UNITED STATES PATENT AND TRADEMARK OFFICE

APPLICATION NO.	FILING DATE	FIRST NAMED INVENTOR	ATTORNEY DOCKET NO.	CONFIRMATION NO.
10/635,249	08/06/2003	Donald C. Roe	8556C	9458

Office Action Summary

DETAILED ACTION

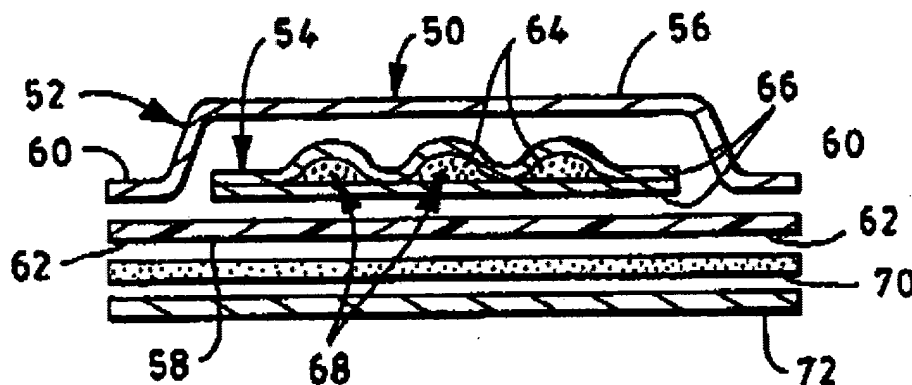
Regarding claim 7, Glaug teaches a disposable diaper (24) having a longitudinal axis, a first waist region (26), a second waist region (26), and a crotch region (30) interposed therebetween, the disposable diaper (24) comprising:

a temperature change element (22, 54) disposed on an inner surface (40), the temperature change element (54) including a permeable layer (56, 66), an impermeable layer (58) disposed opposite the permeable layer (56, 66), and a temperature change substance (64) interposed therebetween, wherein urine deposited onto the temperature change element can penetrate through the permeable layer (56, 66) in a z direction to the impermeable layer (58) and wherein the impermeable layer (58) prevents urine from passing completely through the temperature change element (54) in the z direction and supports the movement of urine in an x-y plane to wet the temperature change substance (64)(col. 7, lines 16-59; col. 8, lines 21-36)(see figures 1 & 3, infra).

**FIG. 3**

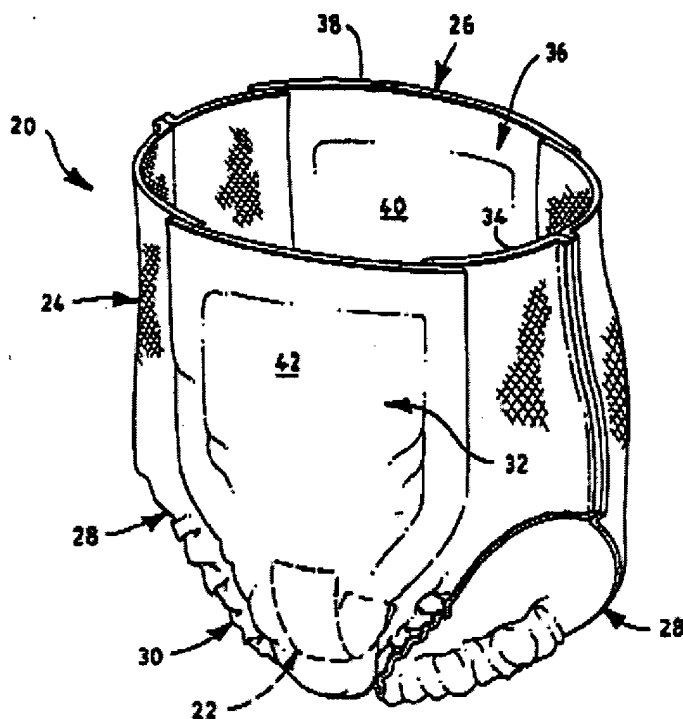
Regarding claim 12, Glaug *et al.* teach that the temperature change element (22, 50) comprises a multiplicity of compartments (68) and the temperature change substance (64) is disposed in each of the compartments (68)(figure 3).

FIG.2

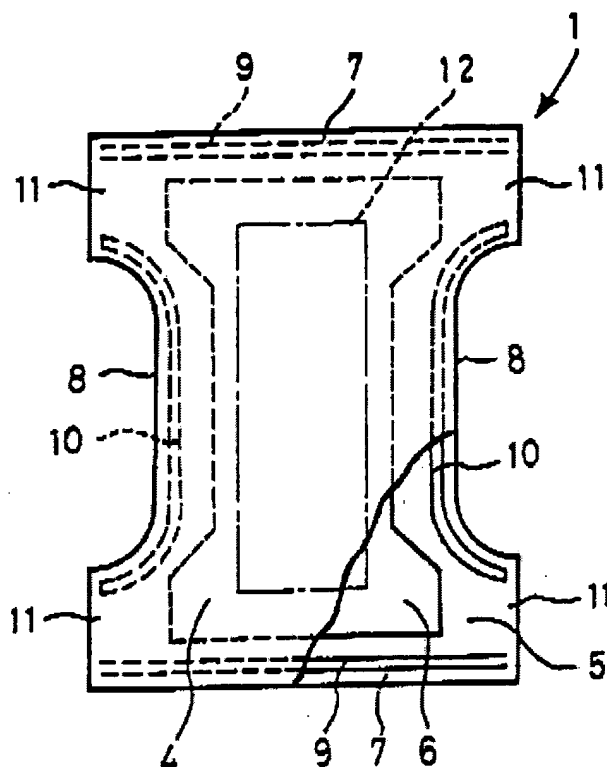
Igaue teaches a training pant (1) comprising a topsheet (4), a backsheet (5) and an absorbent core (6) therebetween (abstract)(see fig. 2, infra).

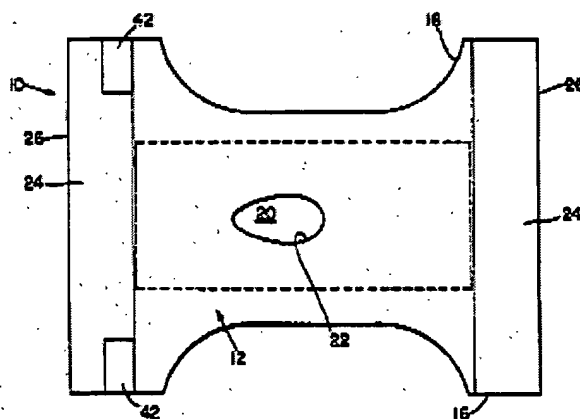
Freeland teaches an absorbent article (10) and/or a subcomponent (12) thereof, with elastically contracted side edges which allow the article to better conform to the anatomy of a wearer (col. 4, lines 4-12)(see figure 1, *infra*).

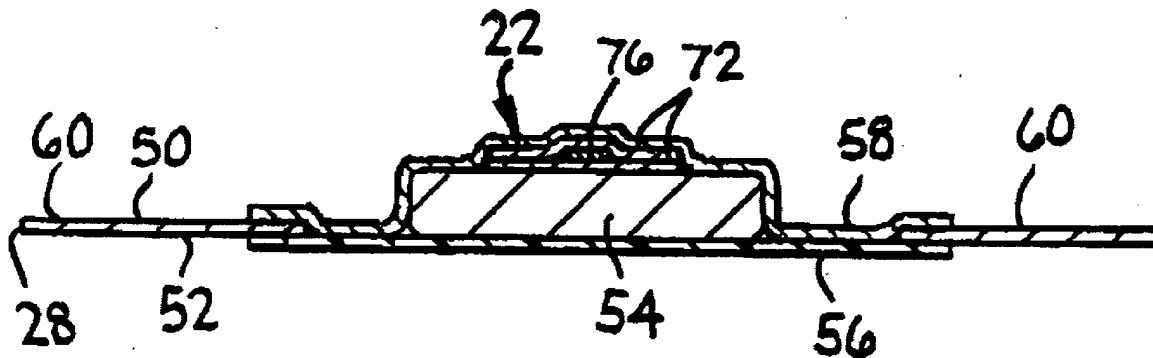
Regarding claim 10, Glaug teaches that the temperature change element is attached to the inner surface (40) of a training pant (24)(fig. 1).
